ADDENDUM #1

Date: January 23, 2018

Fort Langley National Historical Park
Kitchen Upgrade
23433 Mavis Ave,
Langley, British Columbia, Canada.
Project No: R.081108.001

STRUCTURAL ADDENDUM No. 1

AD-S01

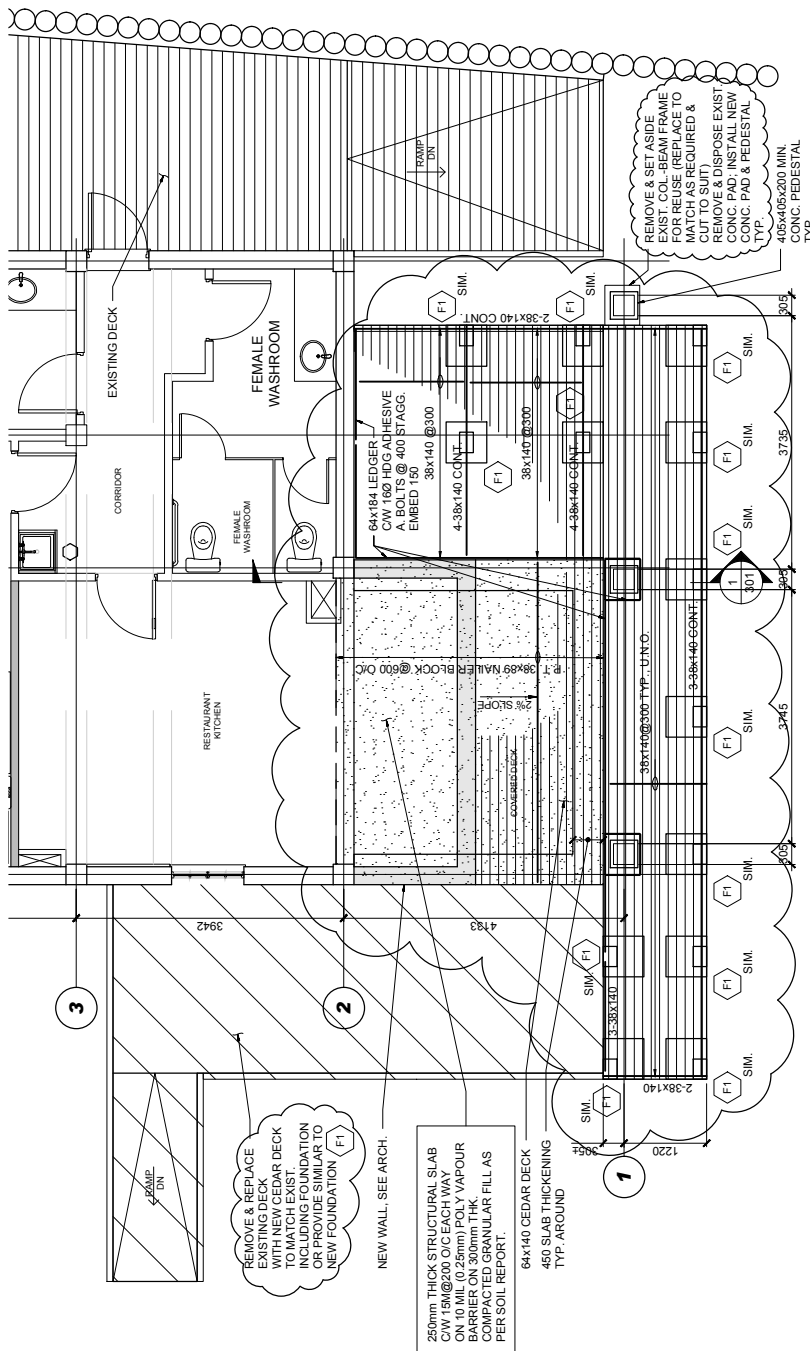
- 2.1 **REVISE** New Main Floor Plan as per sketch AD-S01.
- 2.2 **REVISE** Typical Concrete Footing F1 Details as per sketch AD-S02.

**NEW MAIN FLOOR PLAN REVISED
(REFER TO DWG. S201)**

4
EXTERIOR RAINWATER LEADER BASE

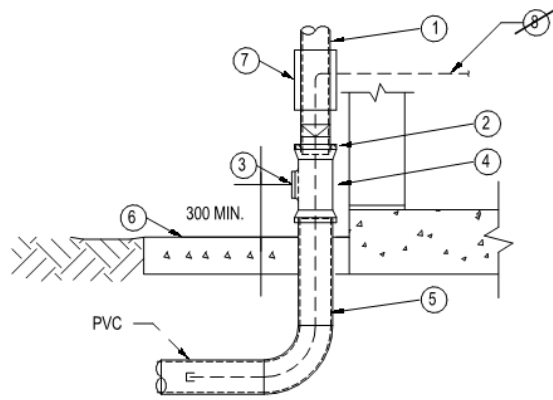
- 6. Refer to IFT Plumbing Drawing P-03, Operation Building – Existing Partial Ground Floor Plan – Reno [GL 1-/A]:
 - 6.1 Add new rain water leader as per drawing below. Install clean-out 300mm above new decking.

2 **NEW SECOND FLOOR PLAN**
A-04 1:50

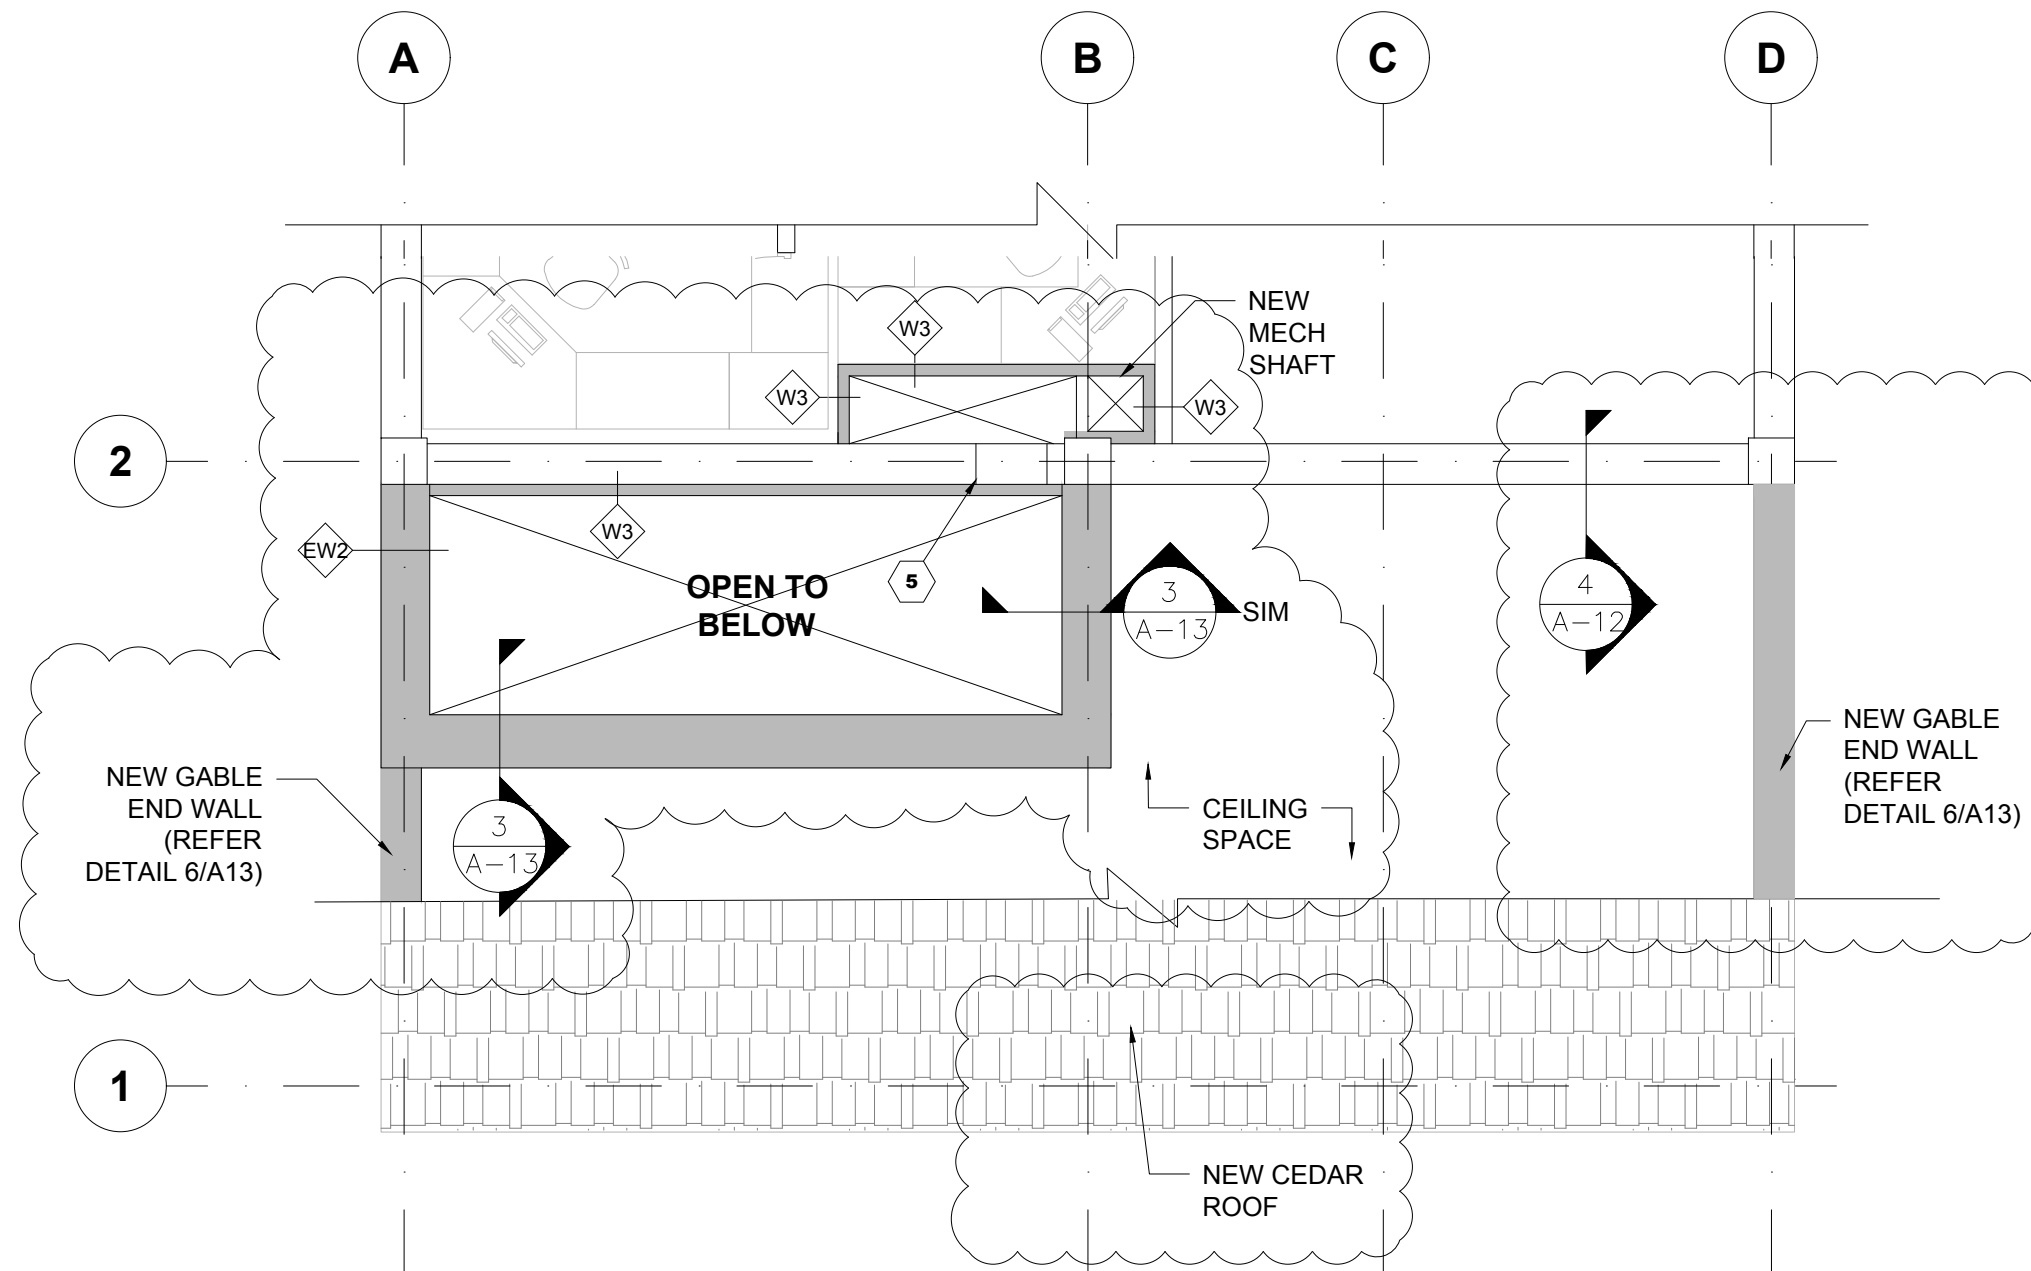
Q2. On Drawing A-04, Can you please provide clarification to the Construction Key Notes?

A1. Construction Key notes apply the drawings on A-04. Scope of work is around the office above the kitchen location.
